# SAN FRANCISCO PLANNING DEPARTMENT

**DATE:** July 11, 2008  
**TO:** Interested Parties  
**FROM:** Joan A. Kugler, Senior Environmental Planner  
**RE:** CASE NO. 96.281E: CENTRAL SUBWAY PROJECT (PHASE 2 OF THE THIRD STREET LIGHT RAIL PROJECT) COMMENTS AND RESPONSES

**RESPONSE TO COMMENTS**  
**VOLUME II**  
**FINAL SUPPLEMENTAL ENVIRONMENTAL IMPACT STATEMENT/  
SUPPLEMENTAL ENVIRONMENTAL IMPACT REPORT**

FIGURE 2-16

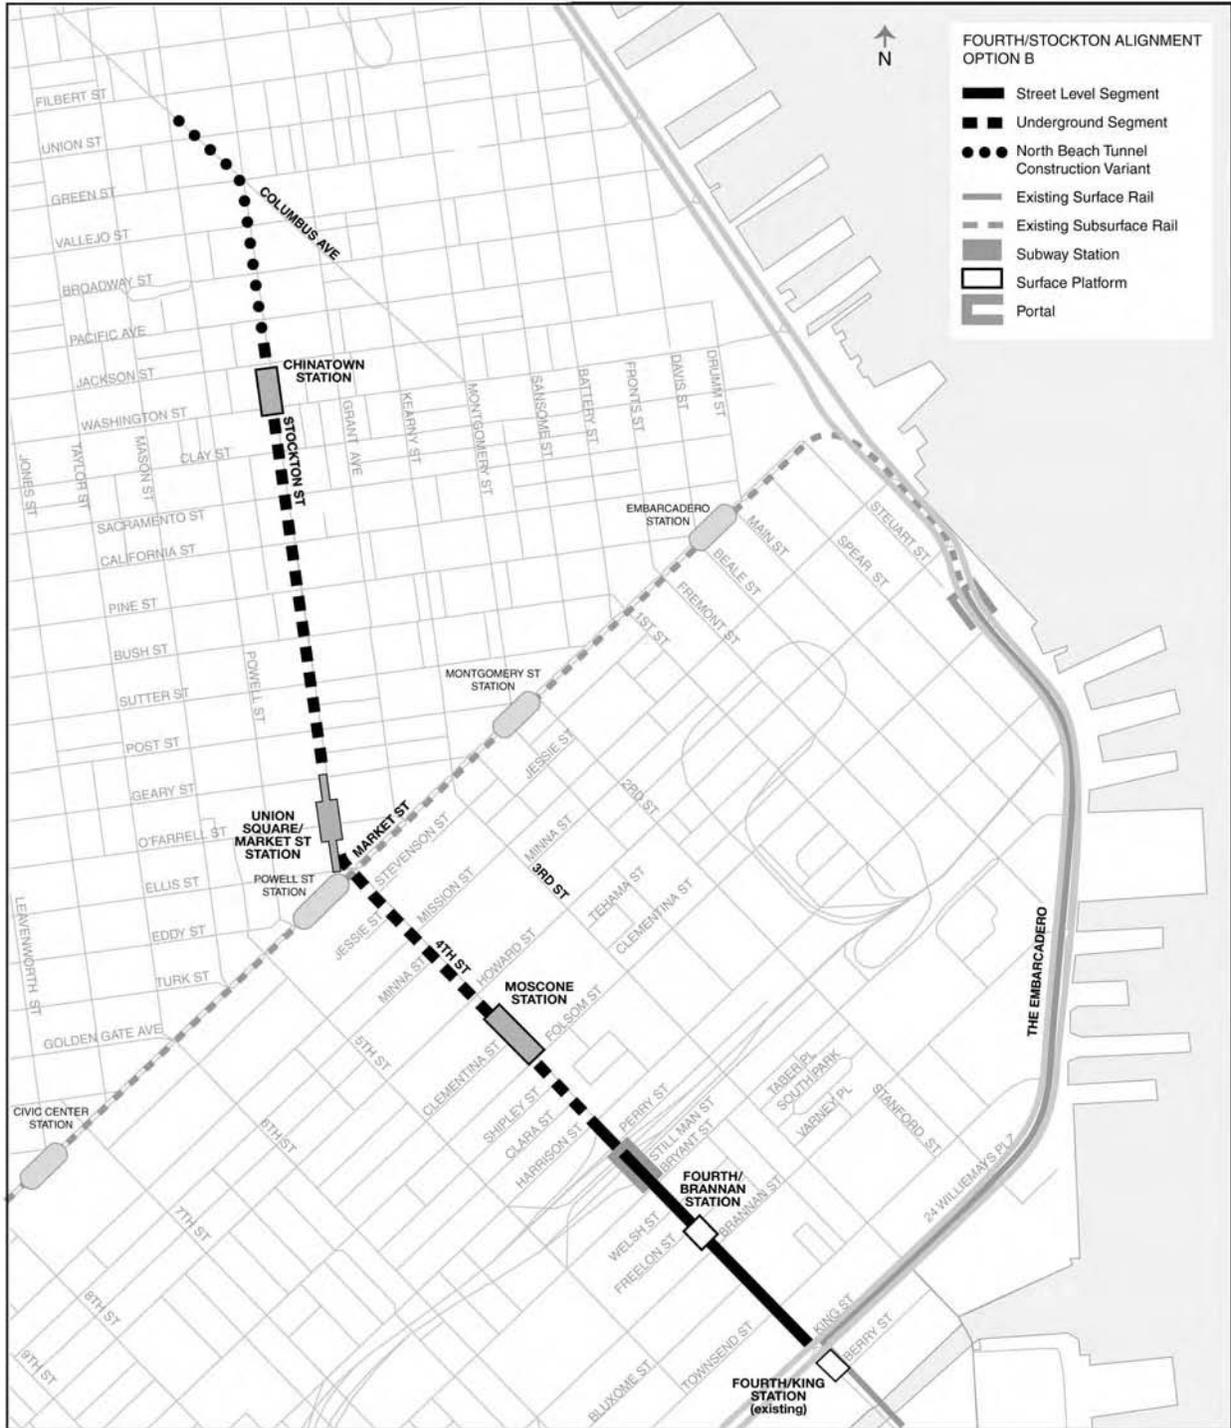
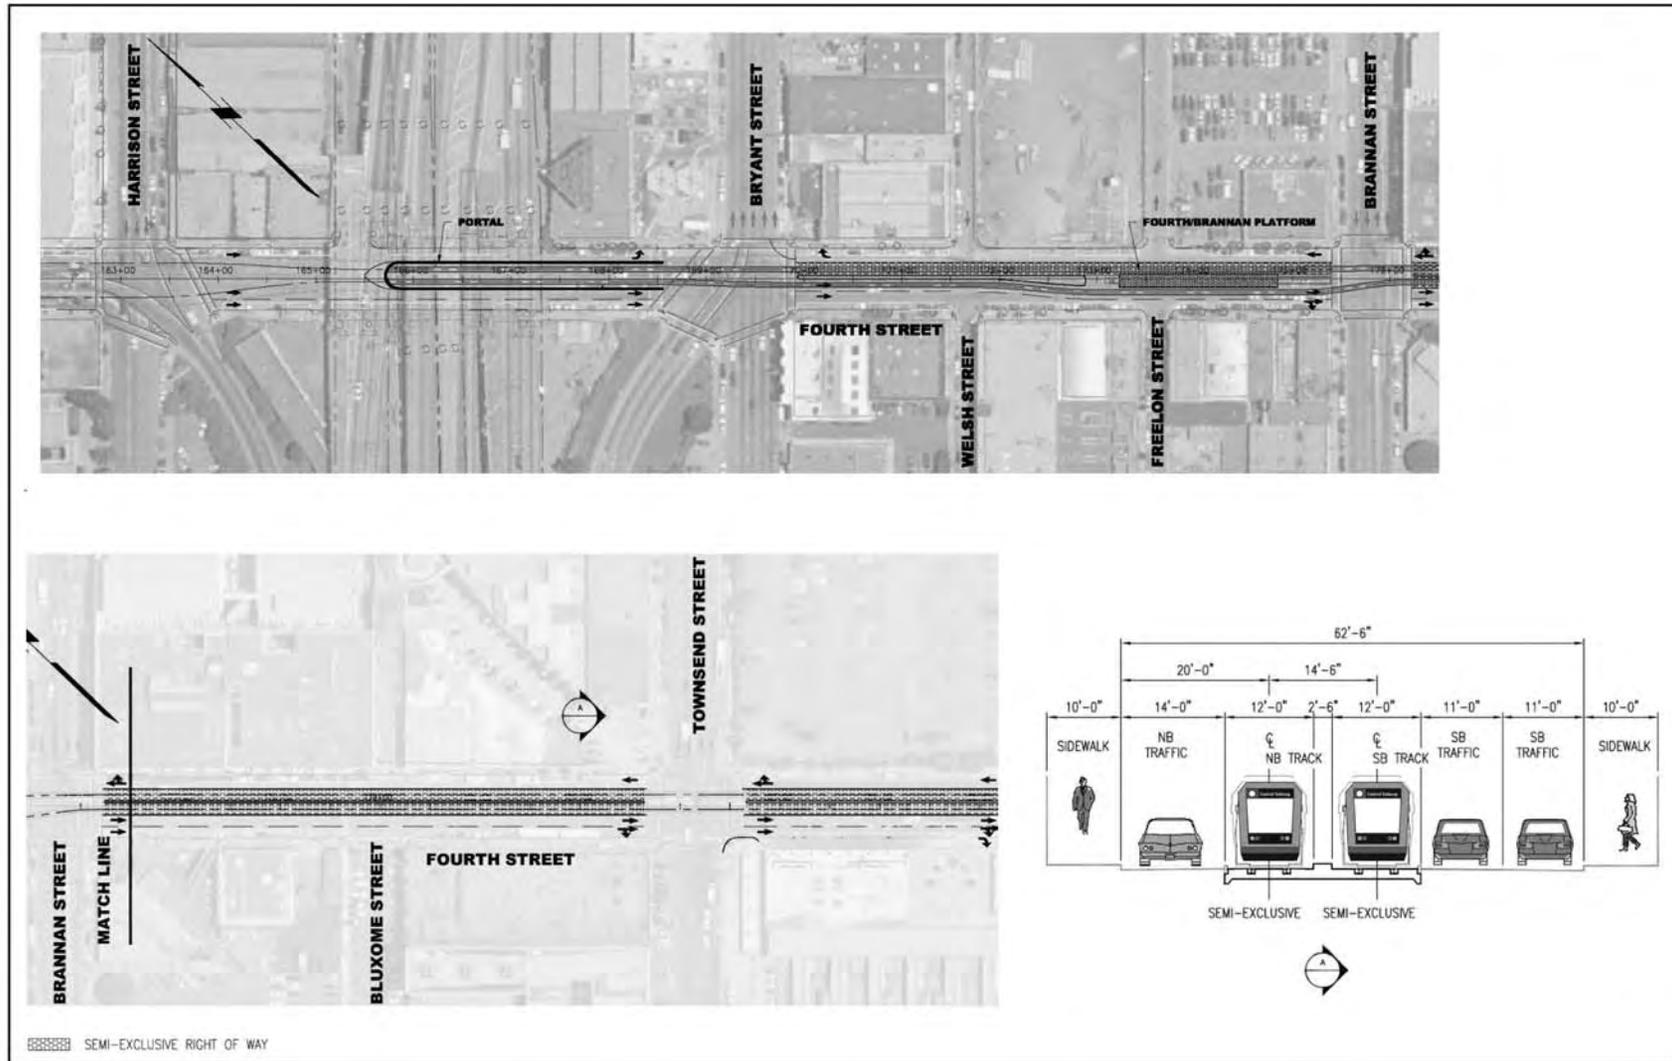
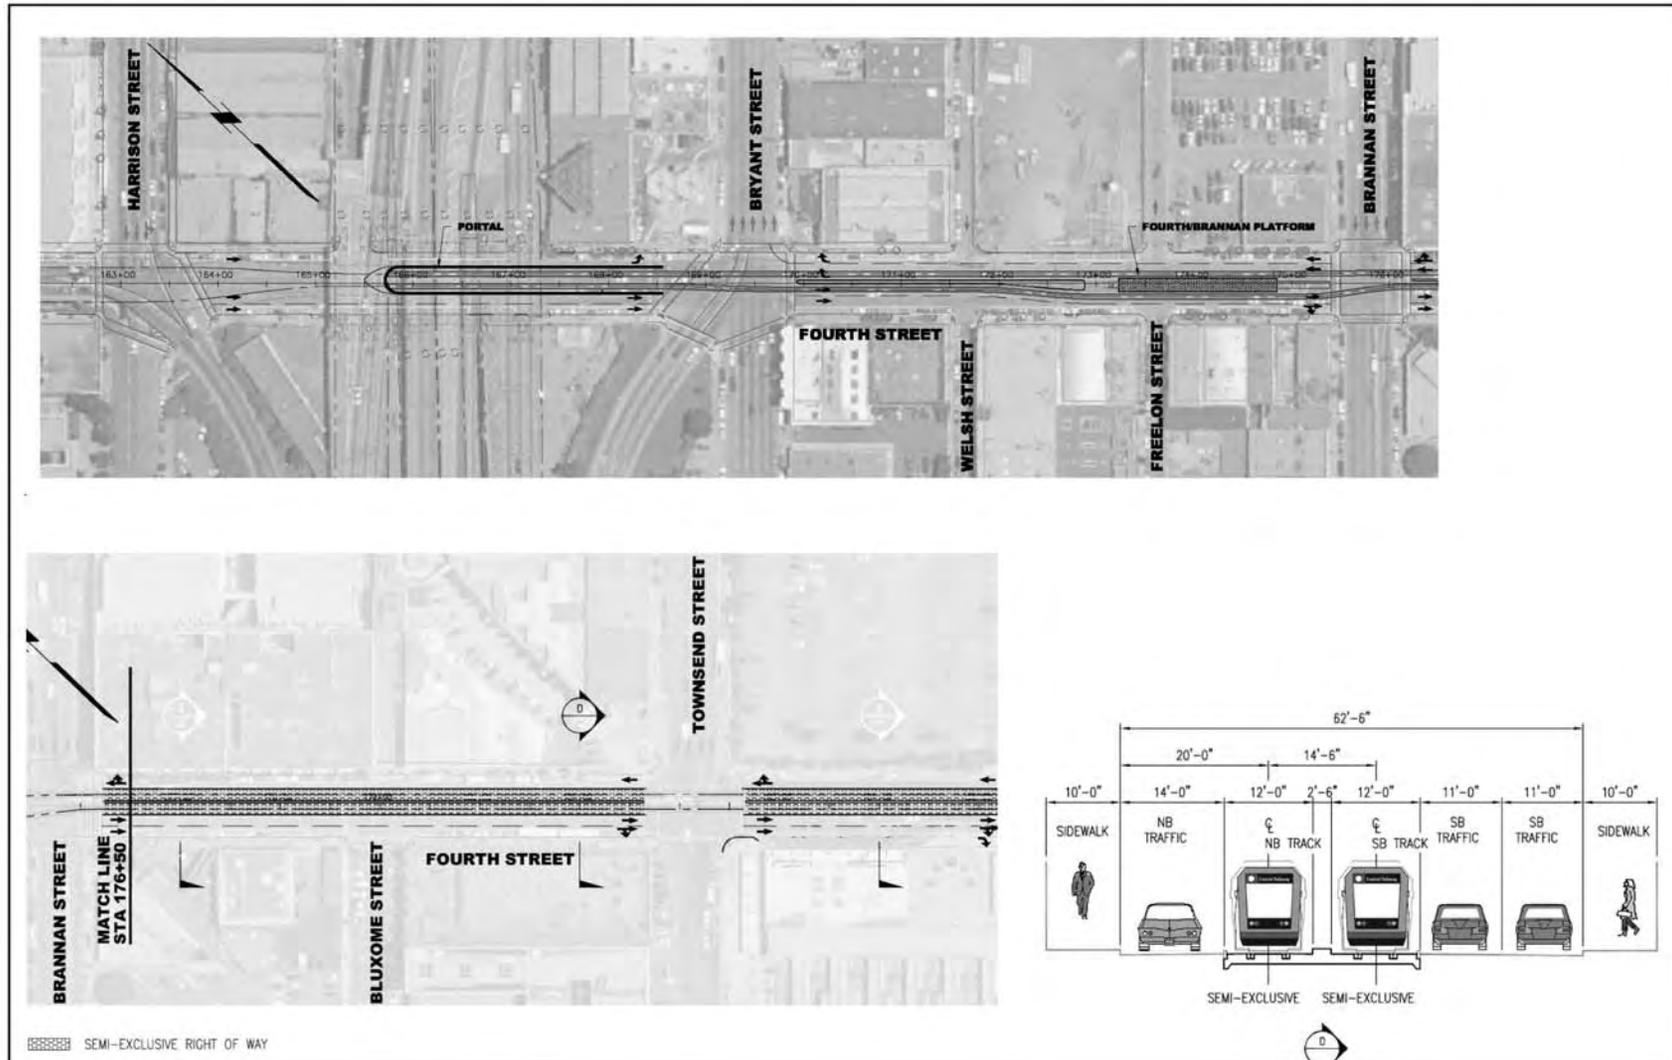
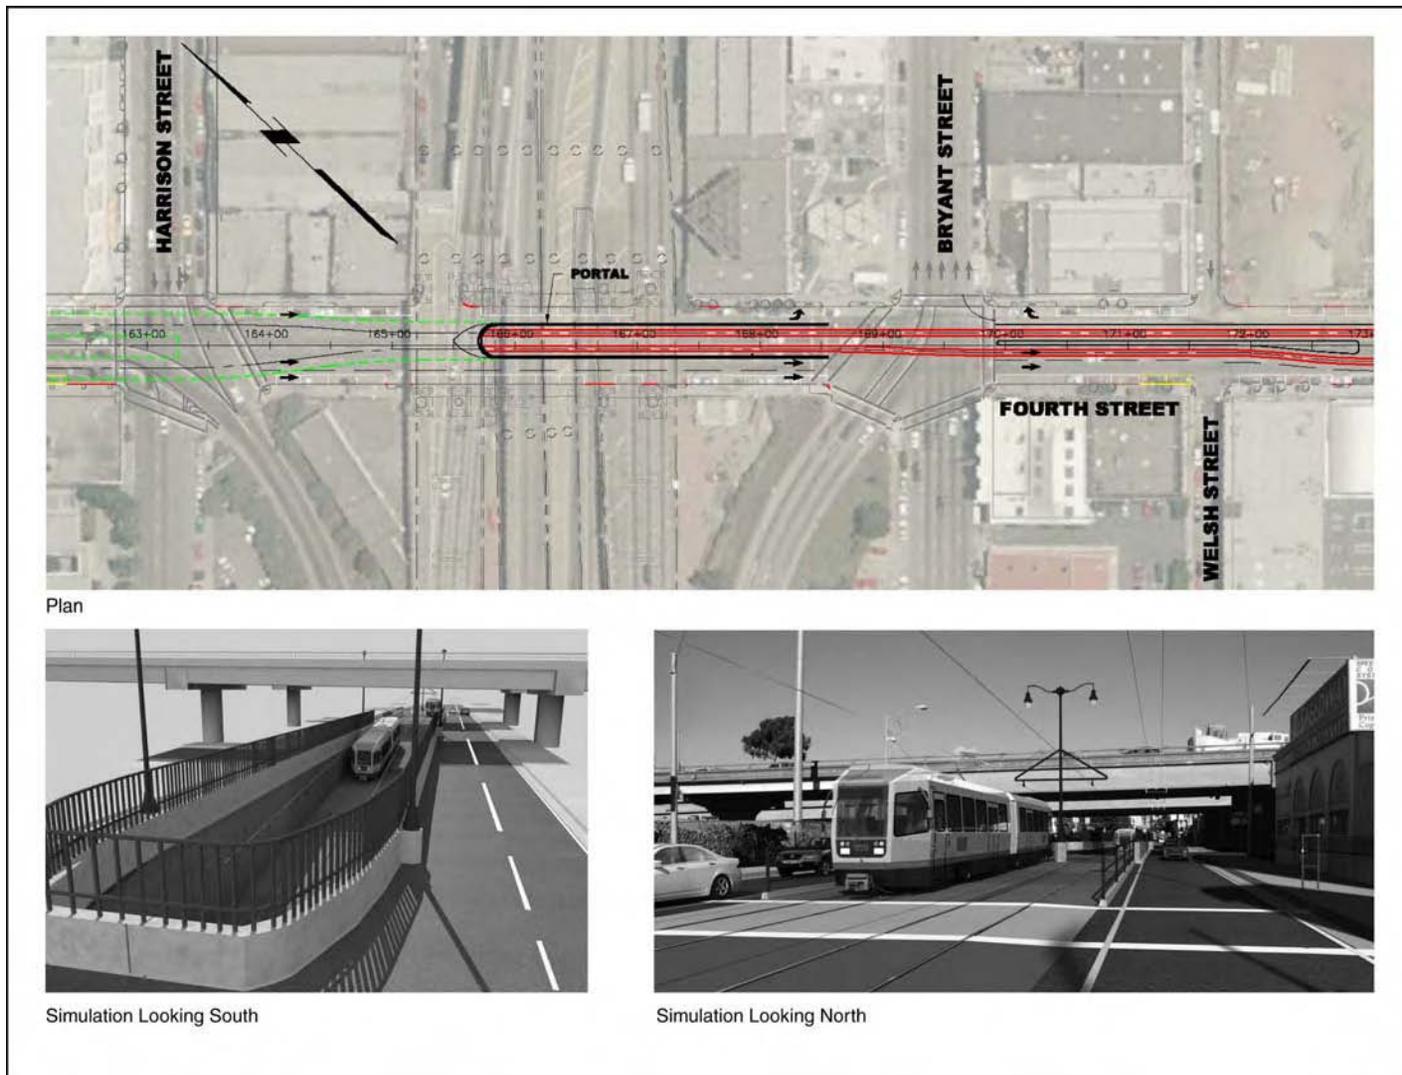
A crash barrier is planned for the portal to protect the entrance structure from turning buses. The current tunnel portal layout plans provide space for the tunnel crash barrier without interfering with the turning path of the bus as it enters the bus storage facility. Figure 2-18 on page 2-39, Figure 2-19 on page 2-41, and Figure 5-10 on page 5-40 have been revised to show the tunnel crash barrier. See Response to Comment R-1 for revised figures.

“After stopping at the station platform on Fourth at King Streets, light rail would continue north on Fourth Street to a double-track portal between ~~Bryant Perry~~ and Harrison Streets under I-80 (see Figure 2-16).”

Figures 2-16, 2-18, 2-19 and 5-10 are revised as noted in the attached pages to reflect the relocation of the subway portal and the placement of a crash barrier.

~~“Because of the location of t~~The portal on Fourth Street just south of Perry Street, under the Interstate 80 Freeway, has been located to accommodate the bus access from south-

Figure 4-4

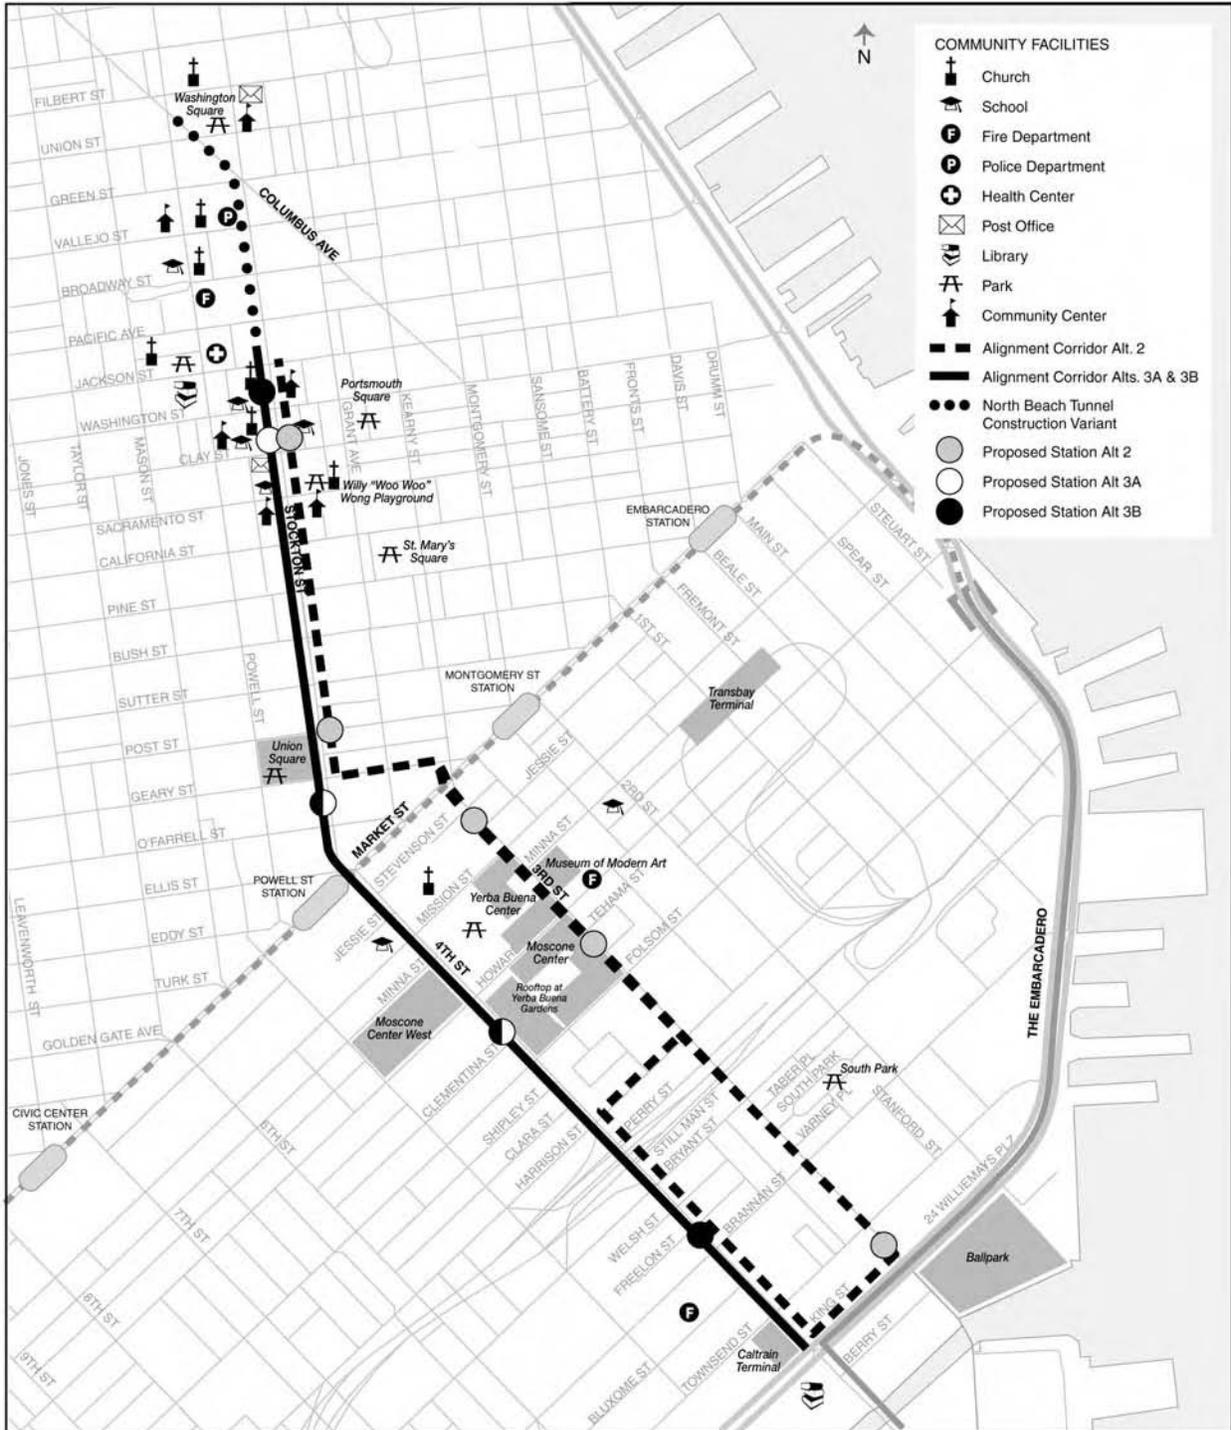
Chinese Hospital	845 Jackson	Private	Medical services
Cumberland Presbyterian Chinese Church	865 Jackson	Private	Presbyterian church
Station 2	1340 Powell	City	Fire house
Gordon Lau Elementary School	950 Clay	SF Unified School District	Elementary School
Salvation Army Chinatown Corps	1450 Powell	Private	Sunday school, senior center, community center
Central Police Station	766 Vallejo	City	Police station
Cathay Post #384 American Legion	1524 Powell	Private	Veterans association
Pin Yuen Senior Recreation Center	799 Pacific	Private	Senior center
San Francisco Chinese Baptist Church	1524 Powell	Private	Baptist church
Chinese United Methodist Church	1009 Stockton	Private	Methodist church

Figure 4-4 on page 4-36 is amended to include the Chinese Historical Society, Donaldina Cameron House, Chinatown YMCA, First Chinese Baptist Church, and Presbyterian Church in Chinatown.
